# Value Engineering Study Report

## Federal Aid Projects: I-75/Union Grove Road Interchange

## South Calhoun Bypass

RE: Submittal of Value Engineering Study Report  
Project Task Order No. 10 – Contract TOOESV06796  
Project I-75/Union Grove Road Interchange  
**Project No.** NH-75-3(203) – P.I. Number: 610870  
Project South Calhoun Bypass  
**Project No.** STP-00MS(7) – P.I. Number 662510  
County Gordon

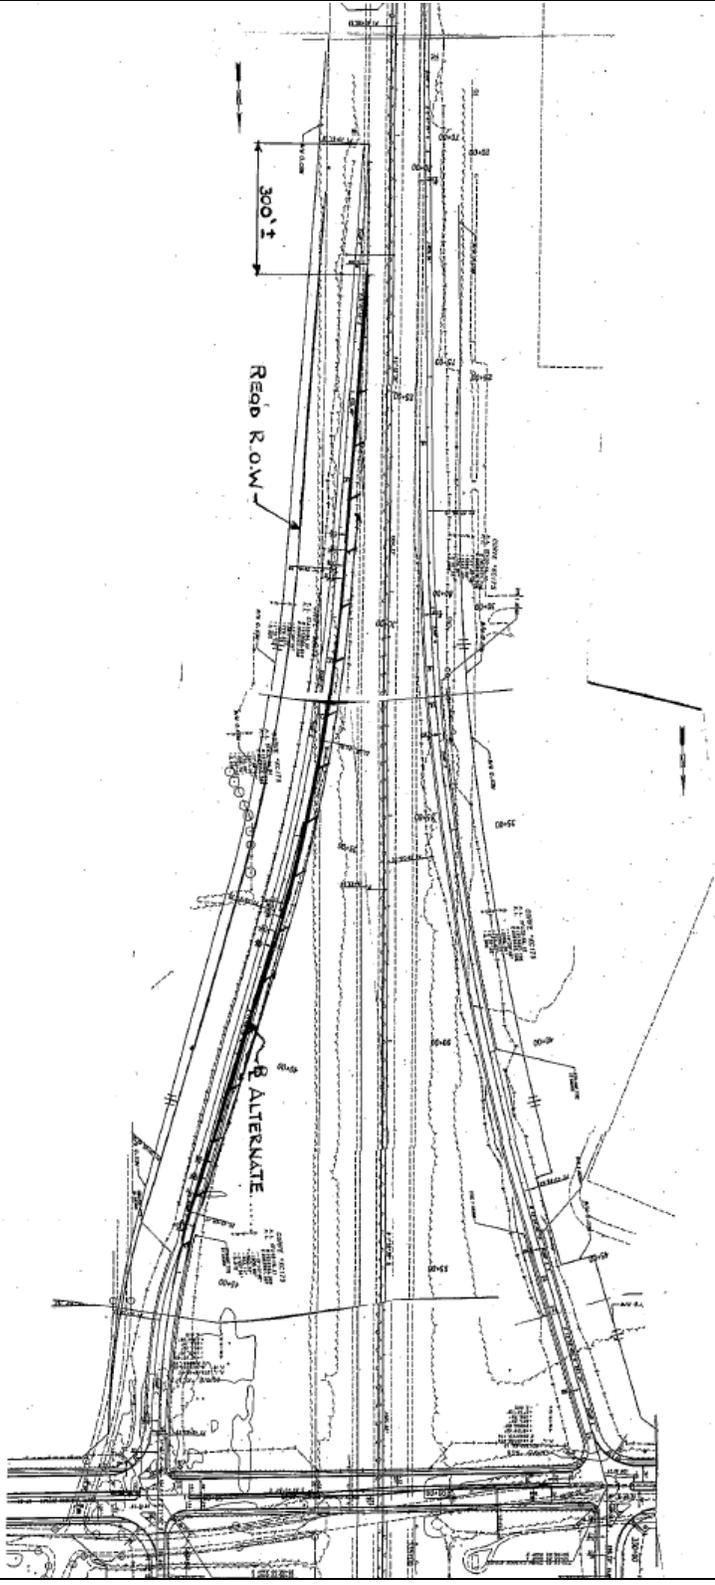
Move tie point of Ramp C approximately 300' while still holding taper rate at beginning of ramp and using same curve radii as original design. Change curve radii of entrance curve to 1200' and move tie point of ramp approximately 620' while using same curve radii of second curve nad taper rate as original design.

DESCRIPTION: **CONSTRUCT CALHOUN BYPASS MAINLINE WITHIN THE INTERCHANGE PROJECT OF ASPHALT INSTEAD OF PCC** SHEET NO.: 3 of 6

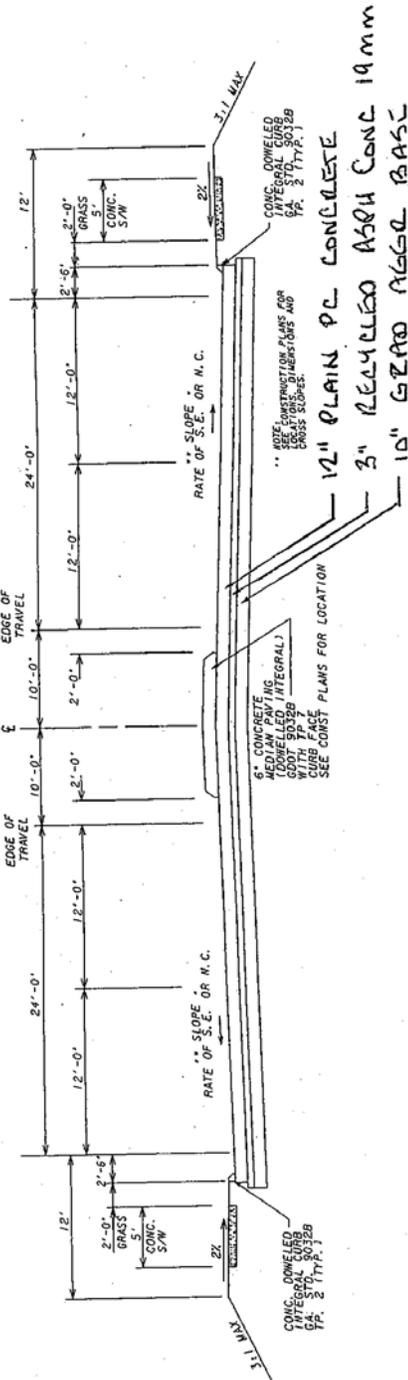
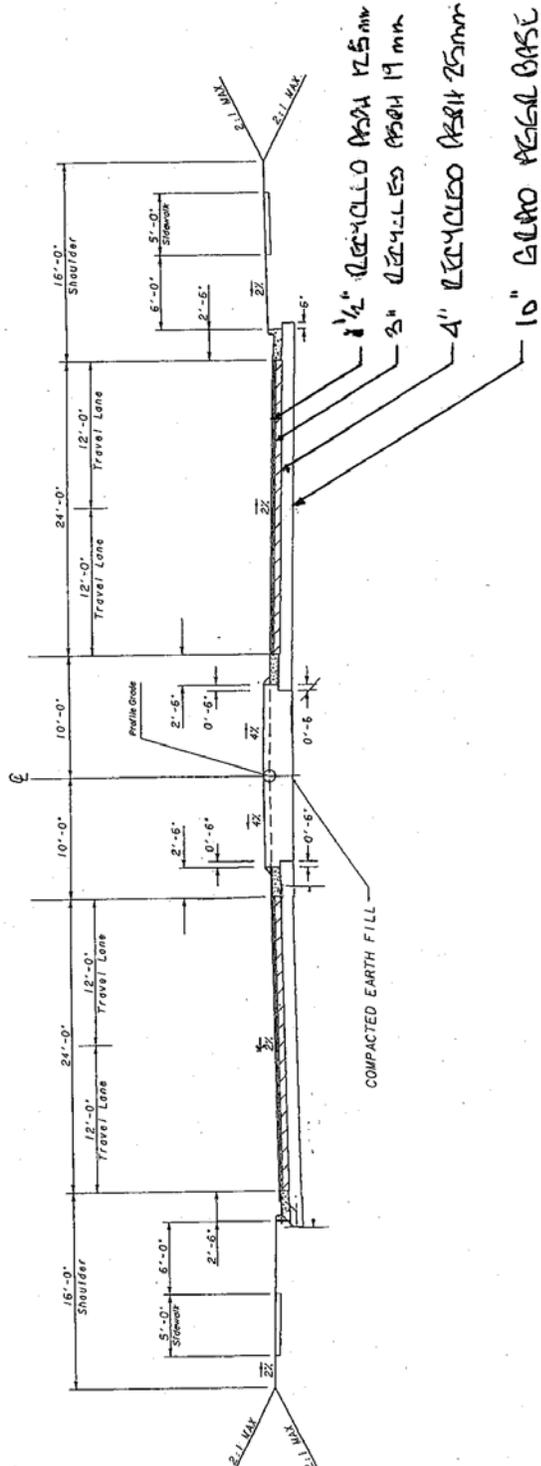
**From a life cycle cost viewpoint this alternative would be seen as not cost effective. From a first cost viewpoint, the initial cost is reduced by \$584,491.**

DESCRIPTION: **SHORTEN BRIDGE, ELIMINATE END SPANS, USE MSE**  
**ABUTMENTS** SHEET NO.: **2 of 4**

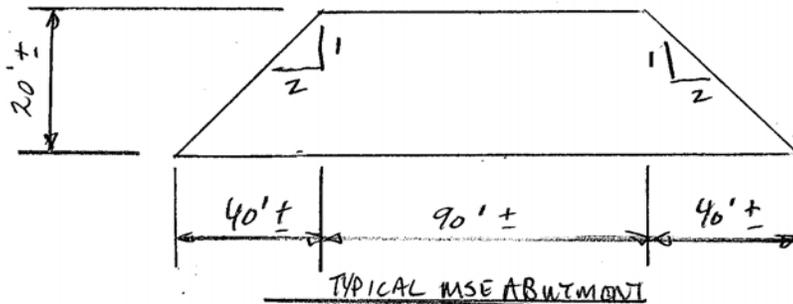
It is common practice to use MSE abutments to reduce bridge lengths. MSE walls can be stage constructed and are economical alternatives to end spans. The MSE wall foundations may not be appropriate if the soils are of very poor quality.

DESCRIPTION: **ELIMINATE GUARDRAIL IN LOCATIONS OF 4:1 SLOPES** SHEET NO.: **3 of 4**

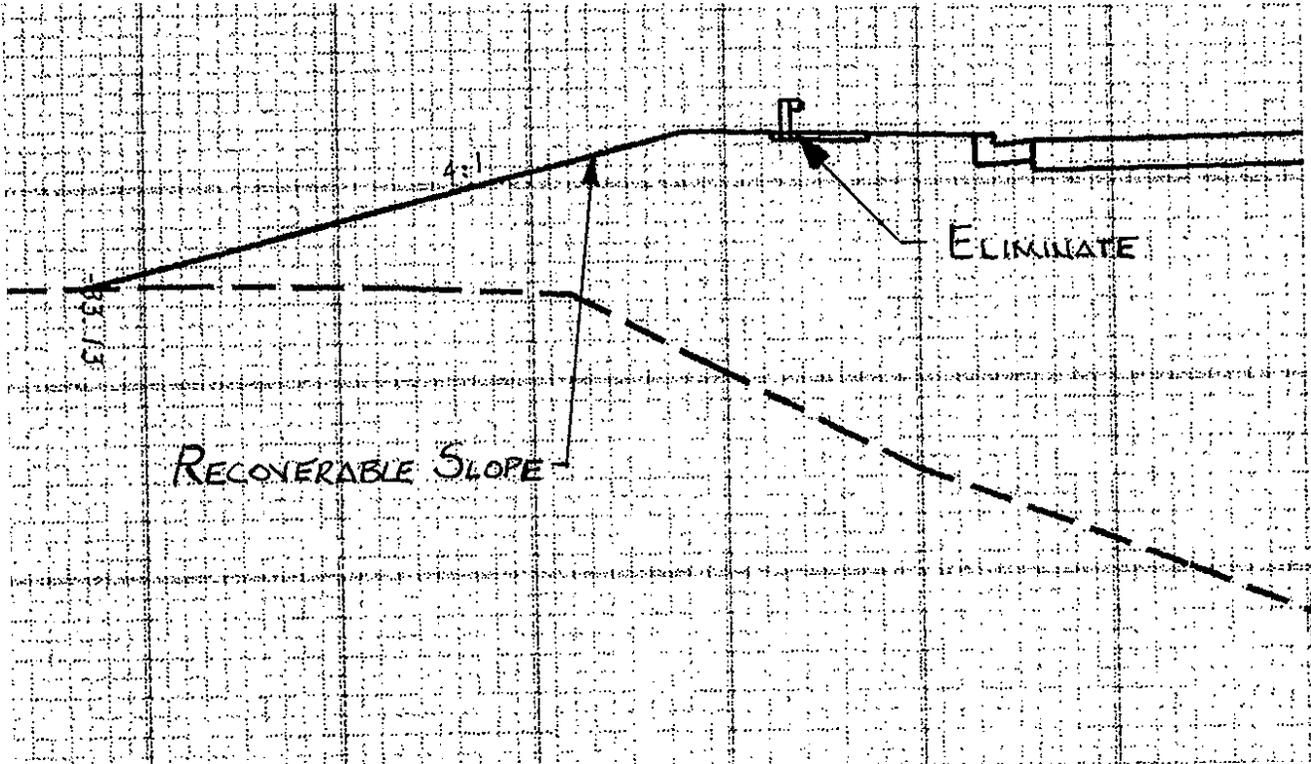
Various locations along the South Calhoun Bypass and ramps show guardrail required to protect 4:1 slopes.

Remove guardrail in these areas since a 4:1 slope is a recoverable slope.

DESCRIPTION: **REDUCE SHOULDER WIDTHS ON RAMPS FROM GORE POINT TO RADIUS AT TOP FO RAMP** SHEET NO.: **2 of 4**

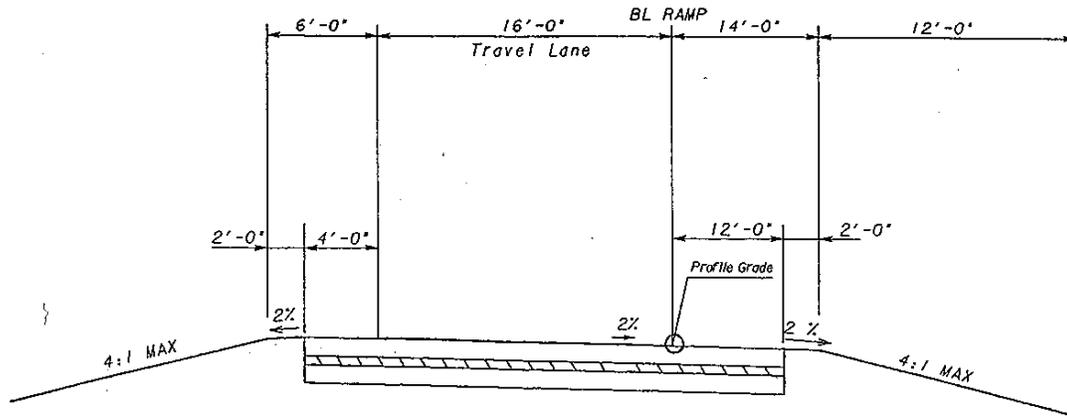
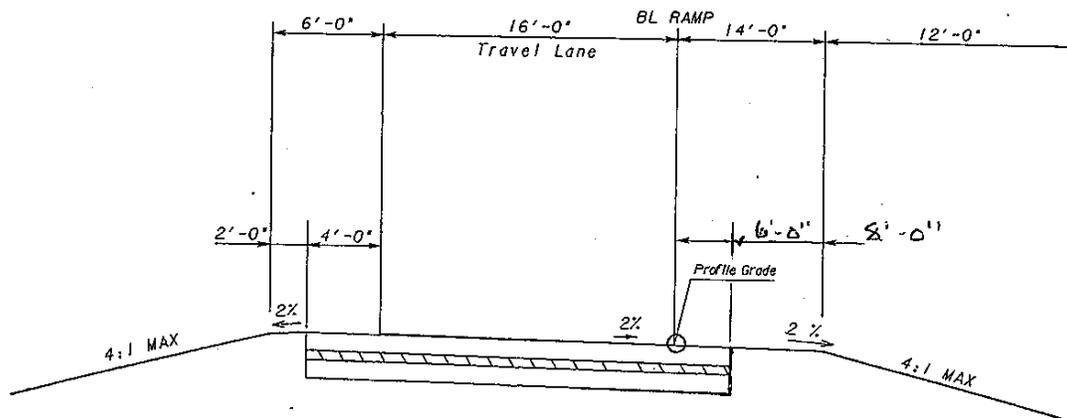
The reduced paved shoulder does not meet the GDOT Design Policy Manual but by retaining the overall shoulder width, sufficient room for emergency parking will be retained. The reduced paved shoulder will apply only to the ramp sections constructed of concrete.

DESCRIPTION: **WIDEN BRIDGE TO INCREASE LEFT TURN STORAGE** SHEET NO.: **2 of 4**  
**LENGTH**

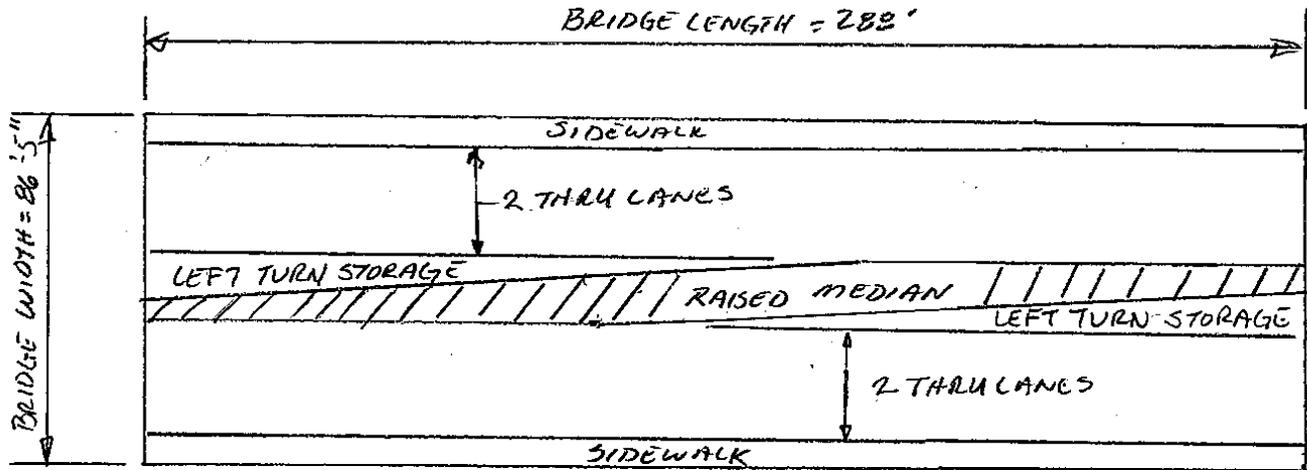
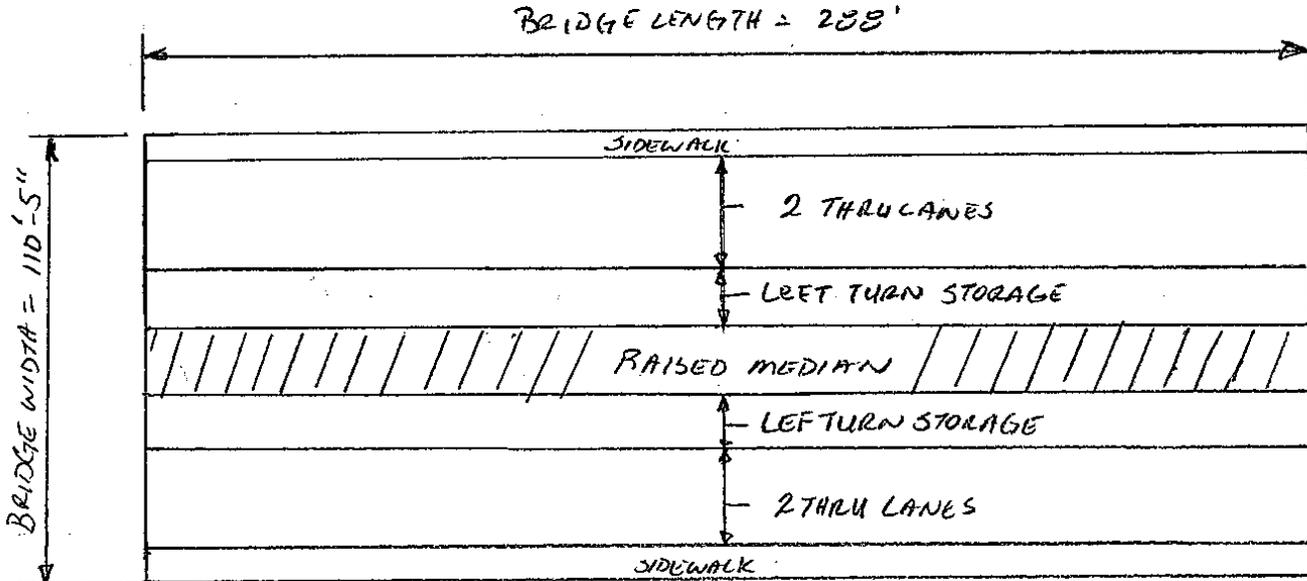
An alternative design is to provide additional storage length of approximately half the bridge length (144 ft.).

Due to the high volume of truck traffic at the interchange it may be desirable to provide left turn storage the full length of the bridge. So that the lanes and medians alignment is maintained, east and west of bridge a full width median is required.

DESCRIPTION: **REDUCE MEDIAN WIDTH**

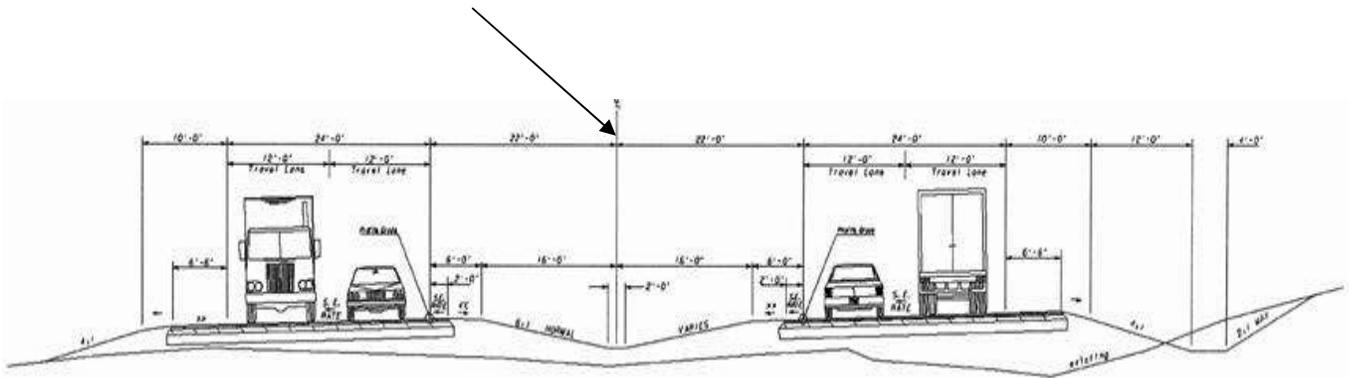
The plan set does not include a depressed, grassed median as part of the typical sections. However, it was the impression of the VE team members that there is such a median that, according to the Concept Validation Report, runs from the western terminus of the project (Station 100+00) to 0.2 mile west of US 41 (Station 272+00 ±). This grassed median is depicted in the report and is shown as 44' feet in width.
